Interactive comment on “Contrasting decadal trends of subsurface excess nitrate in the western and eastern North Atlantic Ocean” by Jin-Yu Terence Yang et al.

Anonymous Referee #1

Review of ‘Contrasting decadal trends of subsurface excess nitrate in the 2 western and eastern North Atlantic Ocean’ by Yang et al.

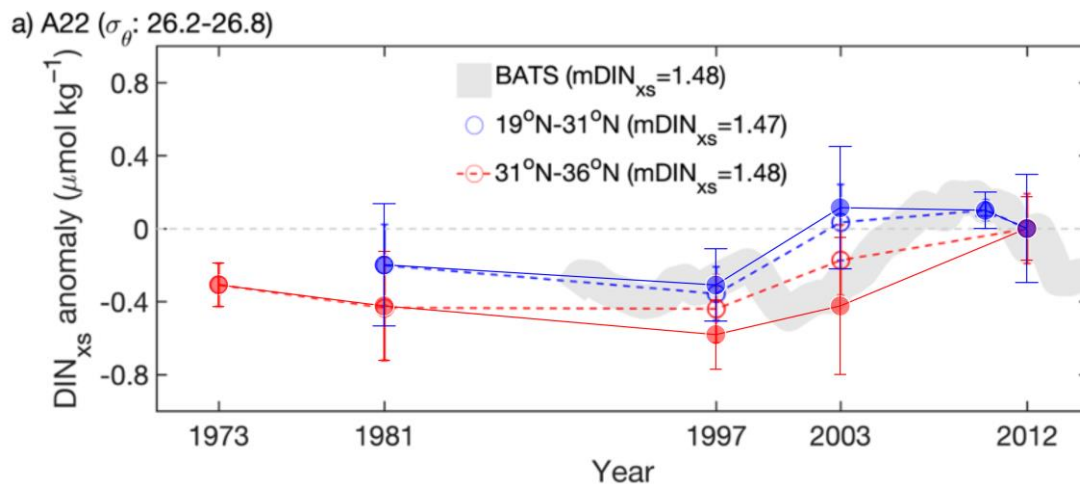
Lines 125–128: Please make it clearer whether this procedure was conducted by the authors of the current manuscript, or if this is a correction made prior to publication of the datasets the authors use. I also do not fully understand what this correction does? Please explain in clear terms why this correction need to be performed (i.e., why do the datasets need this correction to be made comparable in the first place?). Some details for this might be shifted from the supplement to the main text. An alternative option would be to state explicitly that this is discussed in more detail in the supporting information, but it would be useful if the key reason behind the corrections could be summarized succinctly in the main text.

(Explanation provided and changes made): We agree that we did not clearly describe data calibration issue in the original manuscript. In the revised manuscript (lines 136–143) we have included a section describing the data calibration and methods, which reads:

The GLODAPv2 product includes data obtained from > 700 cruises during the period 1972–2013. These large datasets collected in different years and by different investigators may contain some systematic and analytical errors. To remove these systematic errors, quality control of the data was performed by Key et al. (2015) and by Olsen et al. (2016), largely based on comparison of repeated measurements made for waters deeper than 2000 m at the same locations. Any biases found were corrected by applying adjustment factors to the raw datasets, and the adjusted datasets were reported in the GLODAPv2 product (Key et al., 2015; Olsen et al., 2016).

The corrections noted in italics above were performed by two groups (Key et al., 2015; Olsen et al., 2016). More recent data, collected during the 2010s, were not thoroughly compared with the data obtained in the 2000s or earlier. In addition, we removed the influence of remineralization of organic matter by considering the changes in AOU among different cruises. Therefore, we applied additional minor adjustments to all of the datasets obtained over three decades. In the absence of these small corrections (summarized in Table S2) we still found consistent increasing rates of excess DIN using the original uncorrected datasets (solid symbols); for example, since 1997 along the transect A22.
